TECHNICAL NOTE

Job Name: Horsham Transport Study – Regulation 19 Development Scenario
Job No: 332610655
Note No: TN001
Date: 12/04/2024
Prepared By: Norbert Moyo
Checked By: Robert D'Urula
Approved By: Paul Gebbett
Subject: Responses to Pre-Regulation 19 Consultation Queries

2. National Highways Comment Responses – Task 1a

scale VARIOUS	drawn by T.A.S	checked by C.B.W
date NOVEMBER 2020	status CONSTRUCTION	
drawing number 28108 - SK201130.1		rev.

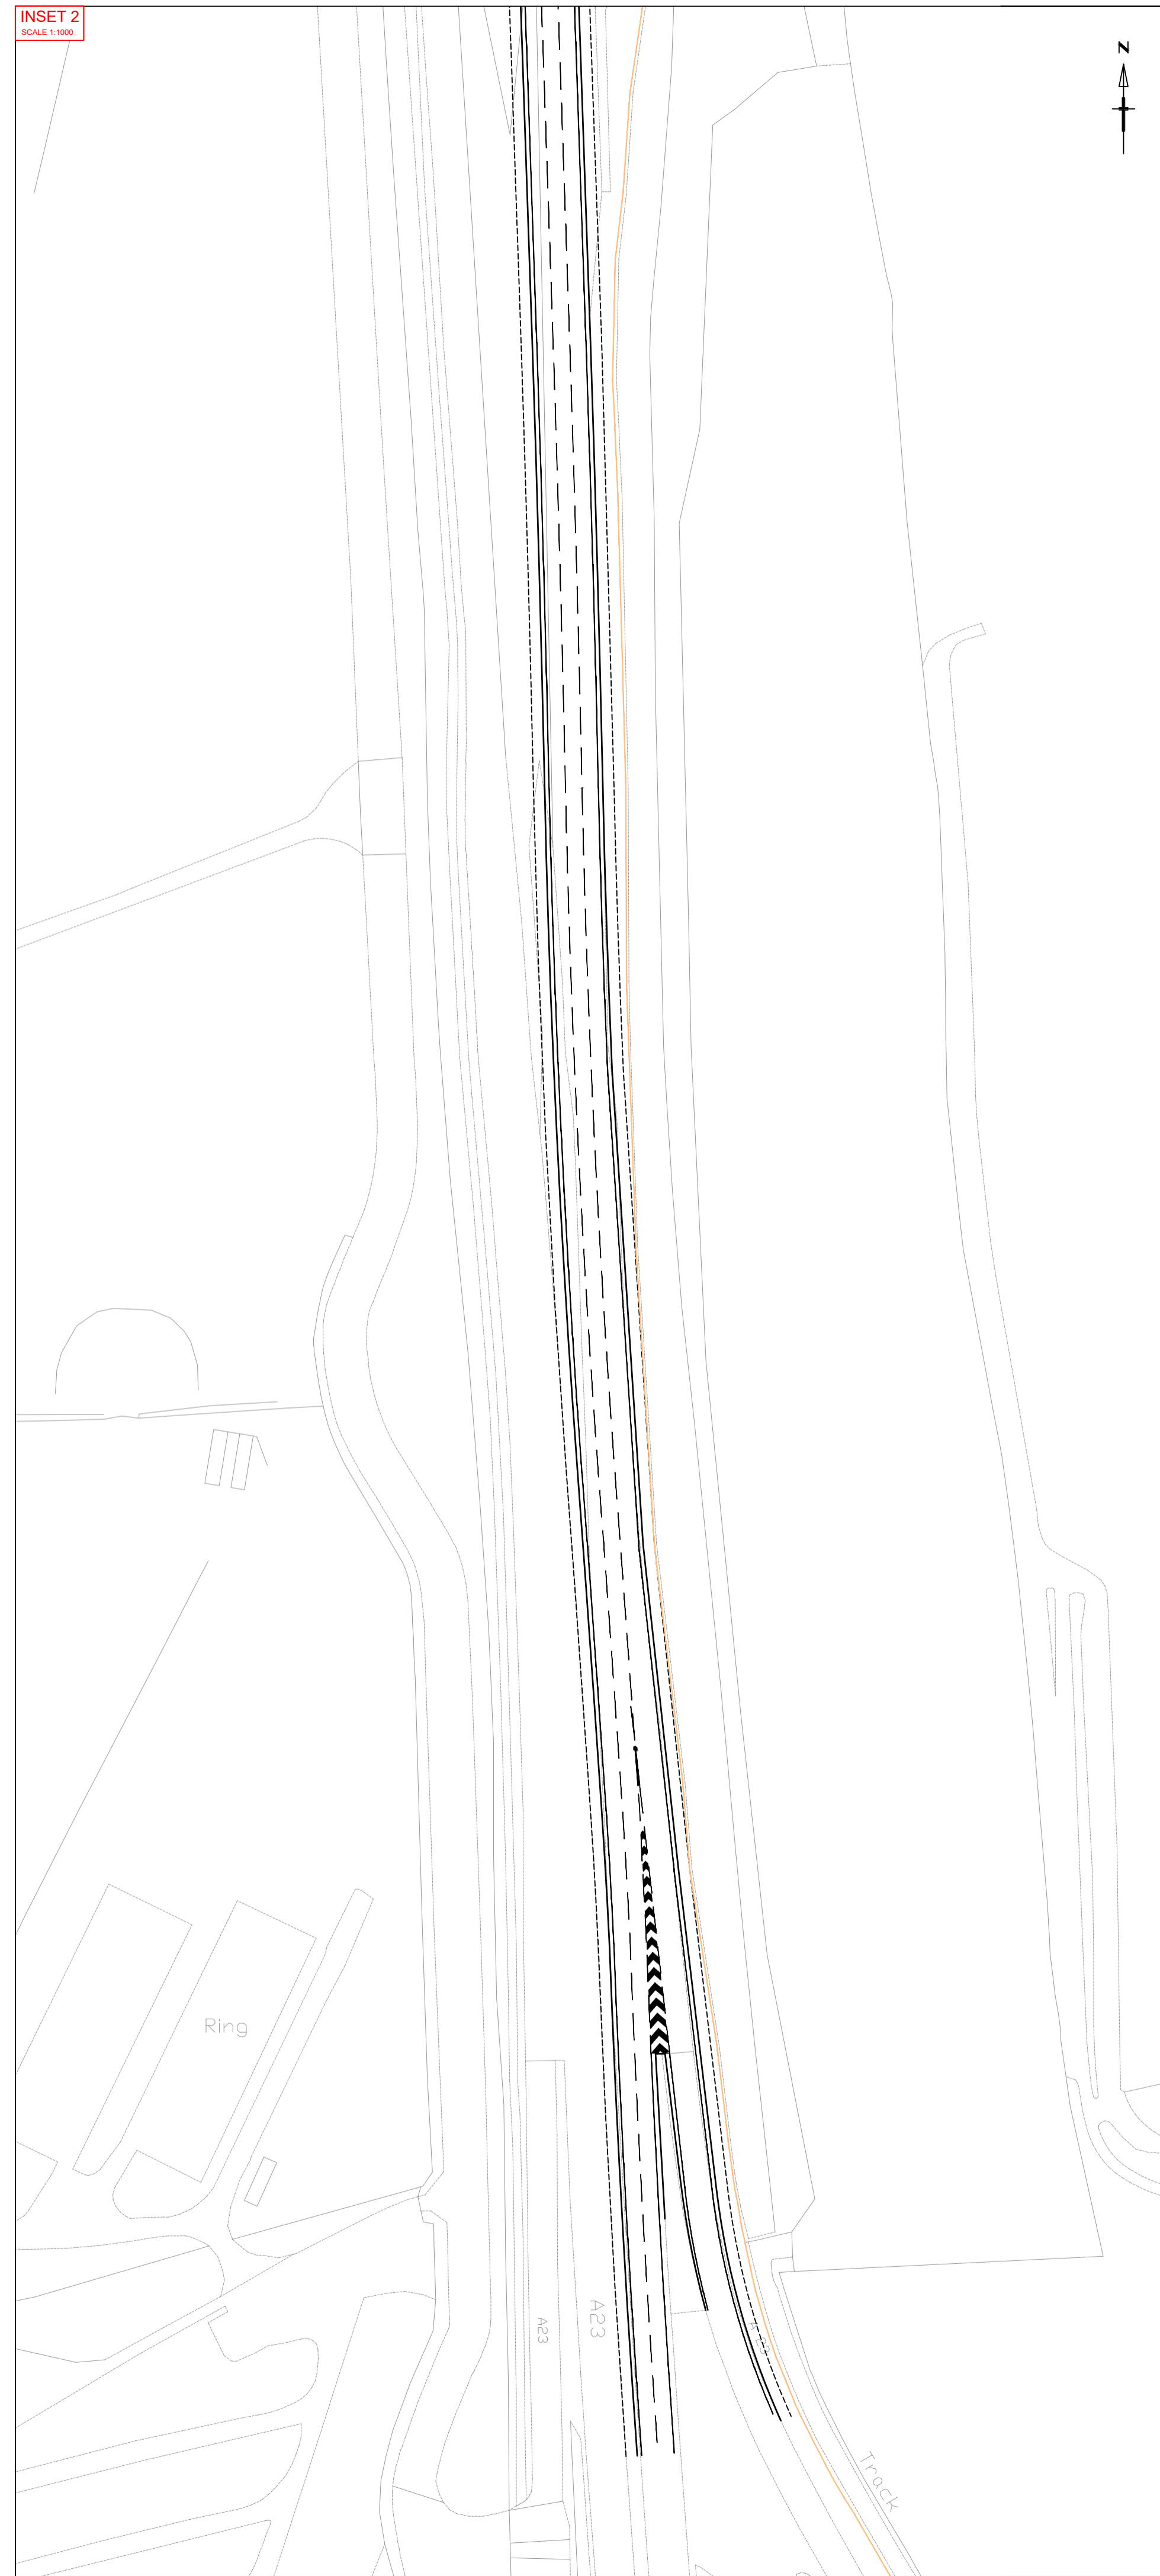
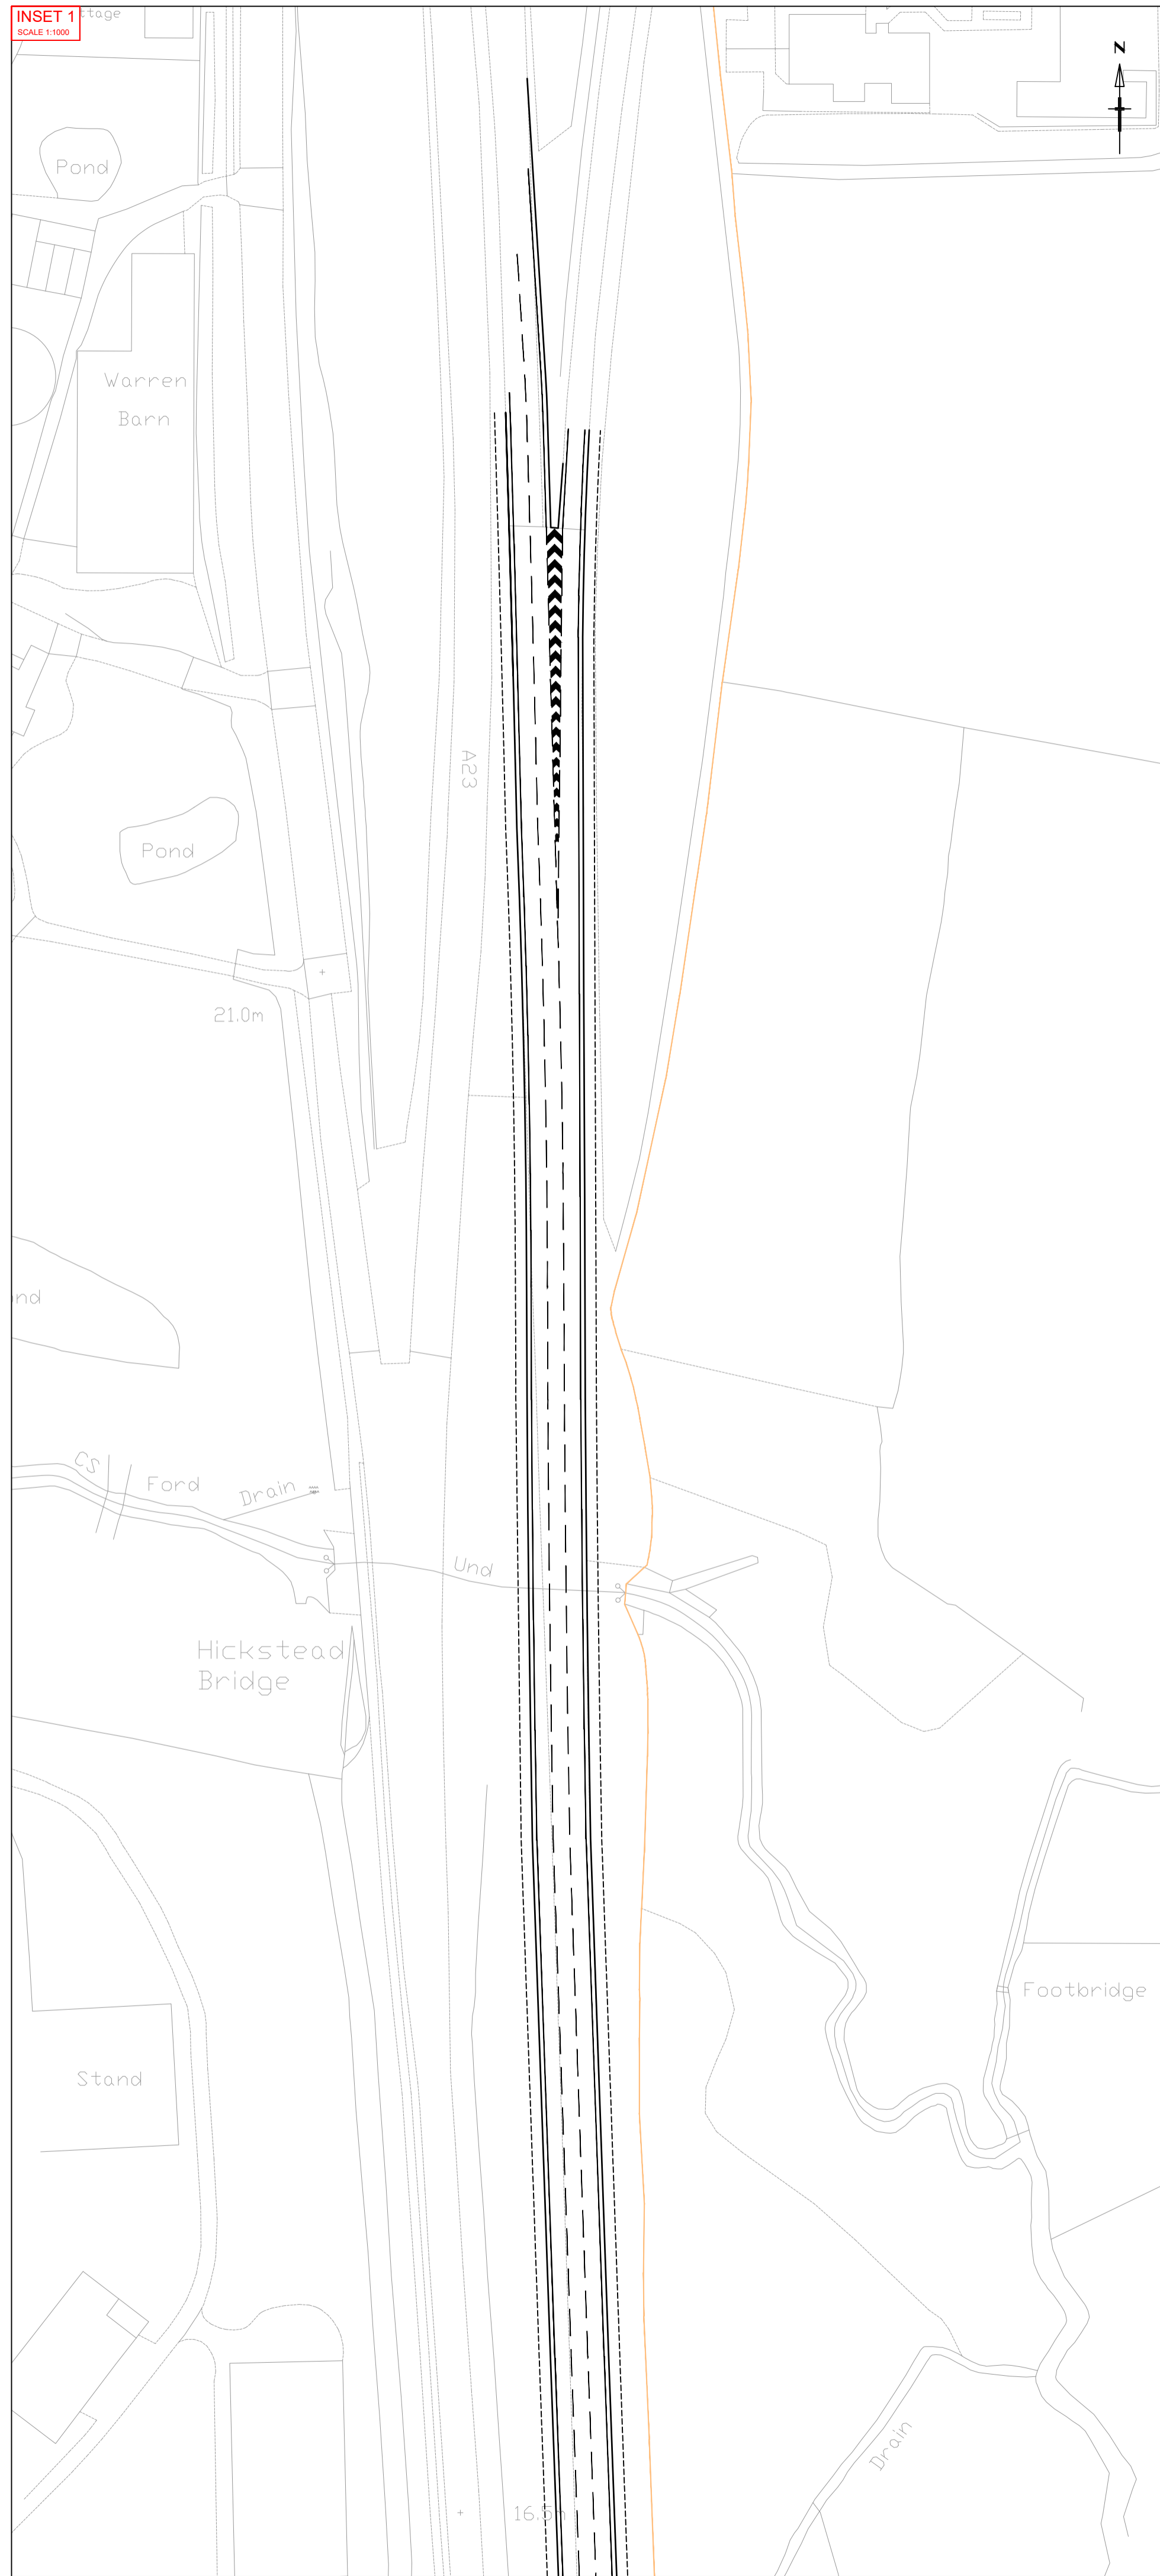
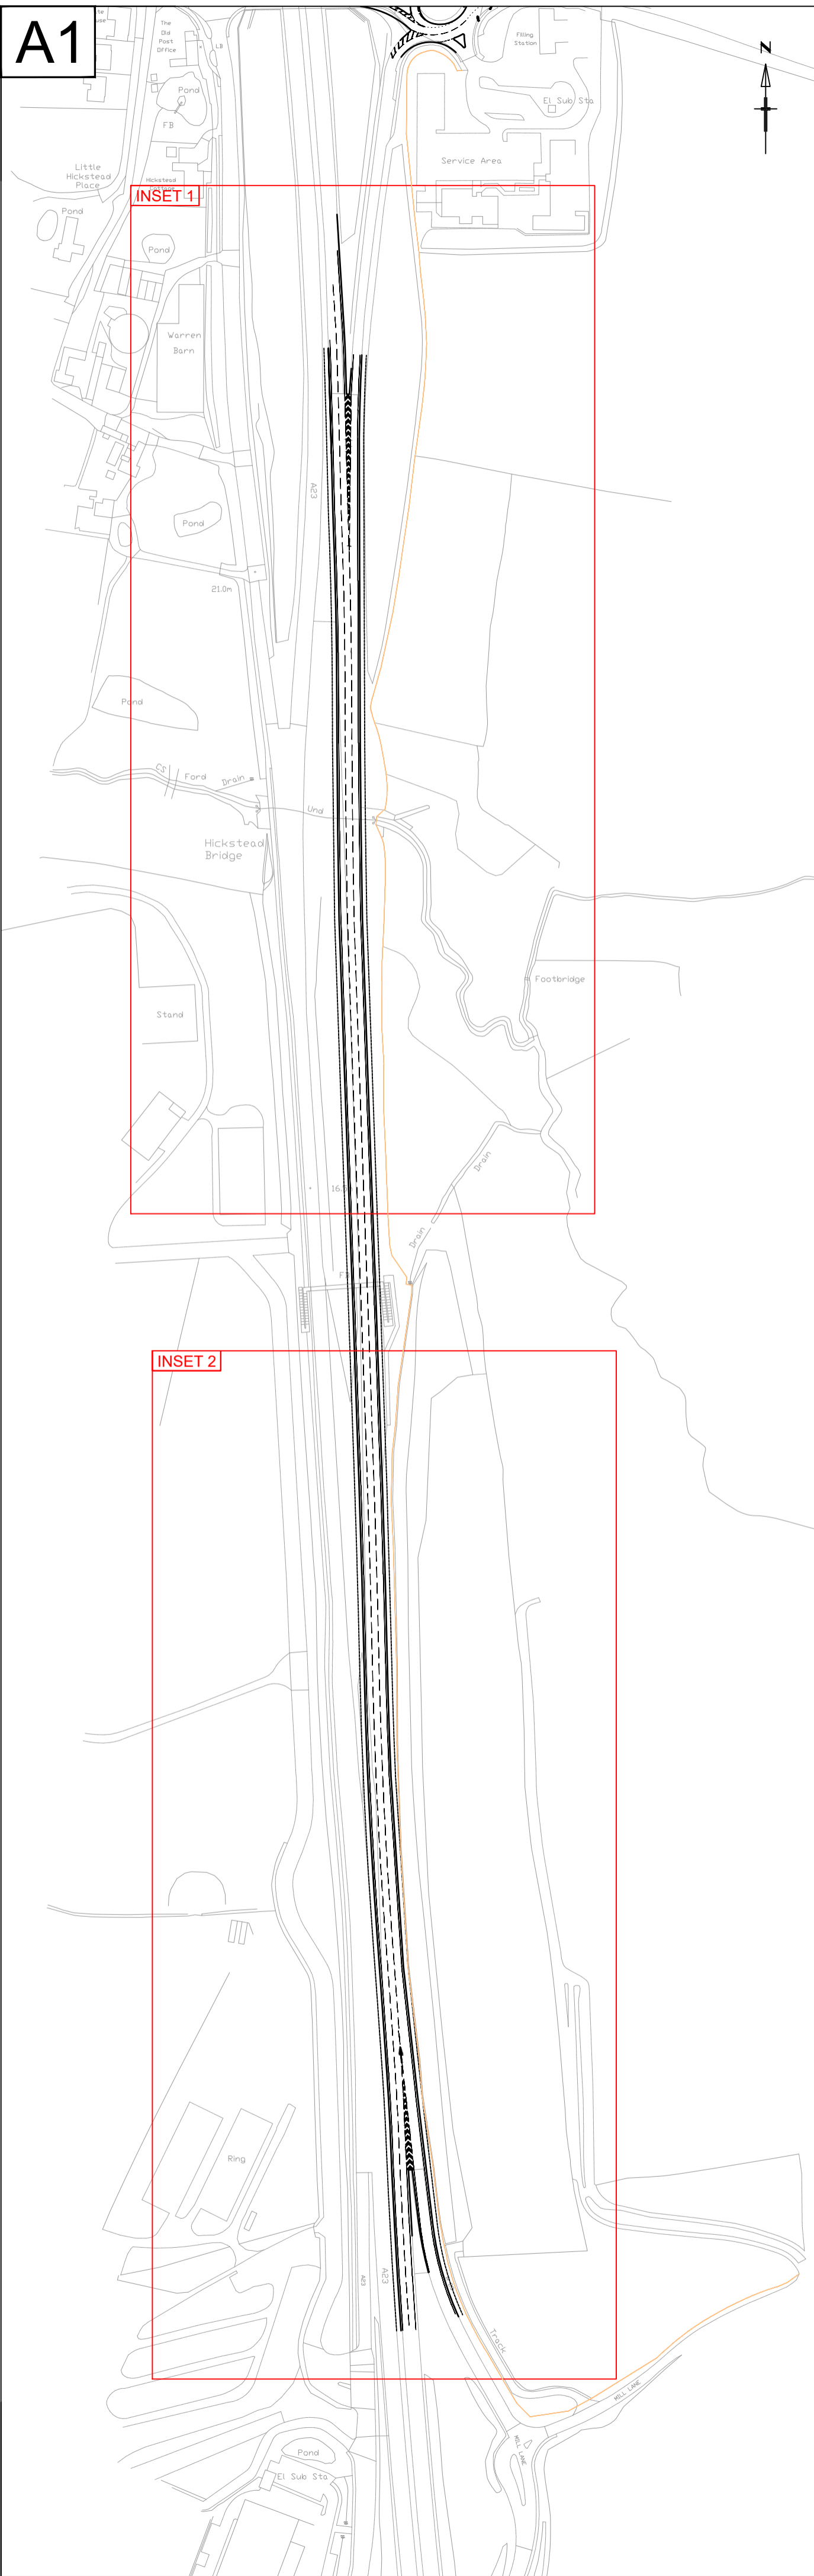
Further commentary should therefore be provided in relation to the assumptions made around the A23 Hickstead junction, in particular any anticipated impacts to the main interchange roundabout as a result of the identified changes to the mainline and junction flows. A test of the planned improvement scheme associated with the Burgess Hill business park, using the strategic model reference case and local plan flows, should also be undertaken (utilising the assistance of WSCC for access to existing junction models).

- Drawing Number 28108 – SK201130.1 Proposed A23 Widening Works Modified Design to Fit Within Existing Highways Boundary pertaining to the southbound carriageway widening of the A23 with a lane gain between the A23 southbound merge and the A23 southbound diverge downstream at the A23 Hickstead Junction – provided as Appendix G.
